Agenda Report

TO: Honorable Mayor and City Council
FROM: Planning & Community Development Department
SUBJECT: PREDEVELOPMENT PLAN REVIEW OF PROJECT LOCATED AT 245 SOUTH LOS ROBLES AVENUE

PREDEVELOPMENT PLAN REVIEW SUMMARY

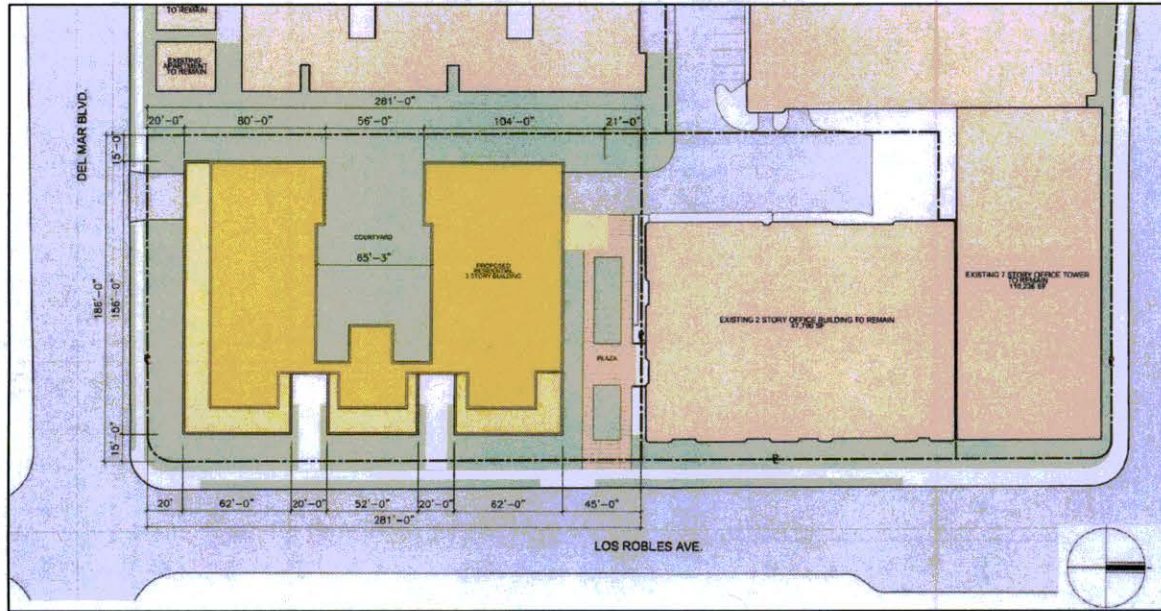
From the preliminary plans submitted to the City, it appears that the project is in compliance with the setback requirements applicable to projects in the RM-48 zoning district. However, further analysis will need to be provided as the project proceeds, demonstrating that the project complies with the minimum setback requirement along all property lines, specifically the front yard setback.

From the submitted information, staff is not able to confirm that no more than 30 percent of the building footprint exceeds the height limit of 40 feet. As the project proceeds, the applicant will be required to provide more detailed information to ensure height averaging is complied with in order to request this approval of the Design Commission. Additionally, the Design Commission may impose additional conditions related to site planning, architectural design, as well as requiring public amenities, including public outdoor space and pedestrian paths.

Del Mar Boulevard is considered the front of the lot, since it is the shortest line of the lot abutting a street. The façade along Del Mar Boulevard has a length of 156'. The building facades along Los Robles Avenue, facing the corner side yard, have a width of

62'. To comply with the façade length requirement, the lengths of the façades need to be reduced to a length not to exceed 60'.

From the preliminary plans submitted to the City, as part of the PPR process, staff concluded that the project did not comply with the 60-foot façade length requirement. However, the applicant has indicated that they would use a Zoning Administrator Interpretation related to massing, dated September 20, 2012, that provides some flexibility in allowing a building façade with a length longer than 60', while meeting prescribed building modulation, along the corner side yard setback. Further information will need to be provided, as the project proceeds, demonstrating that the project complies with the Zoning Administrator Interpretation.

Figure 1: *Site and Surrounding Zoning*

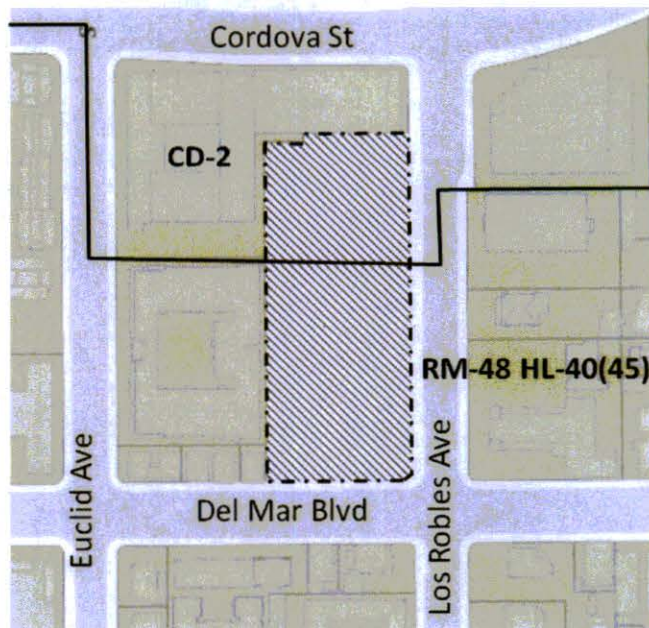
As shown below (Figure 1: *Site and Surrounding Zoning*), the northern portion of the subject site is zoned Central District Specific Plan (CD-2). The southern portion of the site, currently improved with a surface parking lot, is zoned RM-48 HL-40(45) (Multi-Family Residential, 0-48 units per acre) with a Height Limit Overlay Zone of 40'. Therefore, the proposed project development is subject to Section 17.22 (Residential Zoning Districts) of the Zoning Code.
